New Facilities Investment Test for Western Power's Mid-West Energy Project (Southern Section)

Prepared for the Economic Regulation Authority

15 November 2011

Figure 4: MMA and ACIL Tasman RECs market price projections

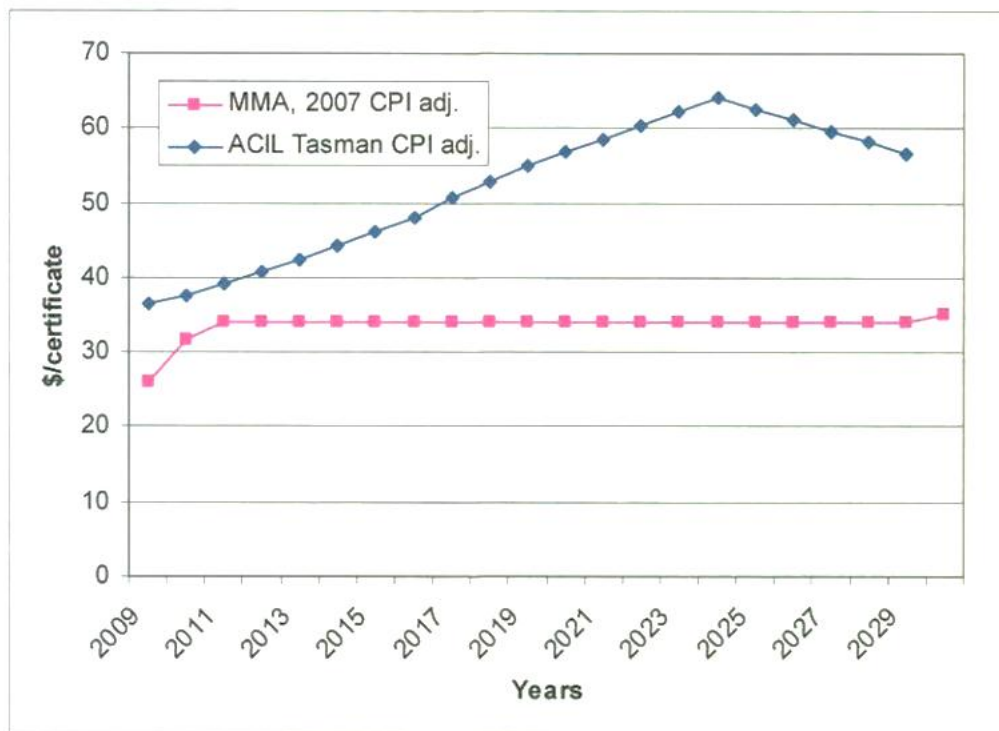
ACIL Tasman assumes that the cost of LGCs will increase over time. This assumption appears at odds with advice provided by MMA to the Department of Climate Change. In answer to questions raised by MJA and the Authority, ACIL Tasman explained that the key differences between their estimate and the estimate provided by MMA are:

The reconciliation provided by ACIL Tasman appears reasonable, however some difference of opinion appears to remain between MMA and ACIL Tasman. The following chart was provided by ACIL Tasman to demonstrate the relative position of each organisation.

The difference between the two estimates would have a substantial impact on the net benefit of the MWEF (Southern Section). Preliminary estimates by MJA suggest that the difference could be over \$70 million in present value terms. However, as both estimates appear plausible and a comprehensive investigation of the difference between the estimates is beyond the scope of this study, we recommend that the estimates provided by Western Power's consultants be considered defensible for the purposes of the NFIT.
